August 2, 2002

**RE: CASE # 1R-0344
EAST GRIMES BATTERY #2
HOBBS, NEW MEXICO**

**Coleman Street
Site Plan
Borehole Locations**

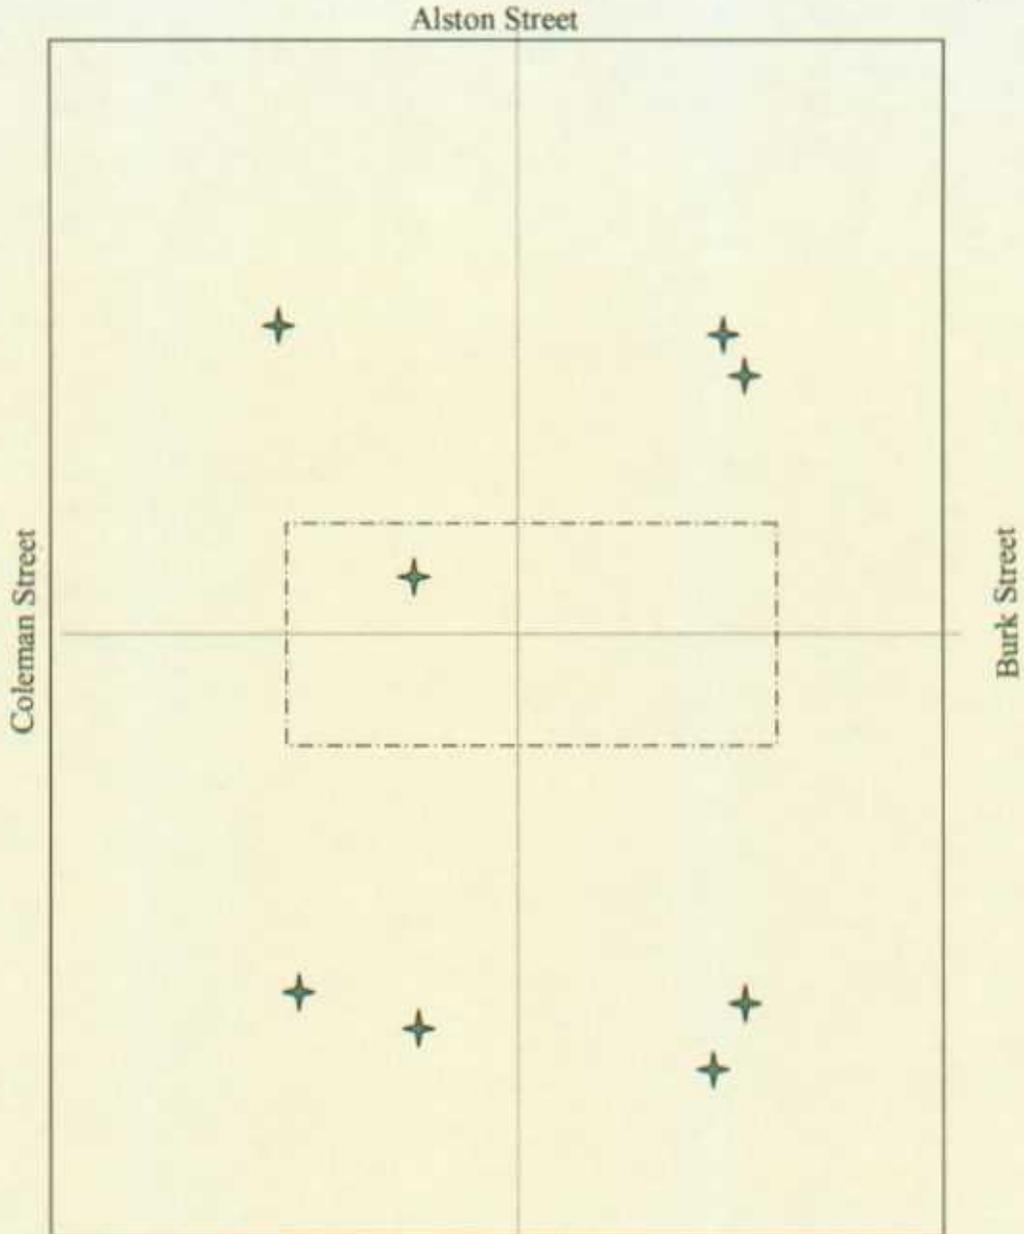
1. The discussion of the soil sampling results on Page 2 of the August 27, 2001 document states that "Minor traces of metals were detected in the surface samples; however, no levels that would be harmful to the public were detected". Please provide the OCD with the technical basis and health-based criteria for this conclusion.
2. The "Site Plan Borehole Location", Figure 6, page 12, does not contain borehole identification numbers which correspond to the borehole numbers listed in Table #3 on page 5. Please provide a revised figure which includes this information.

This letter is in response to your letter requesting additional information on Case #1R-344, East Grimes Battery # 2. I will address the technical basis and health based criteria for the conclusion that the metal concentrations detected at this site would not be harmful to the public and I have enclosed a revised site plan map labeling the boreholes installed at the site.
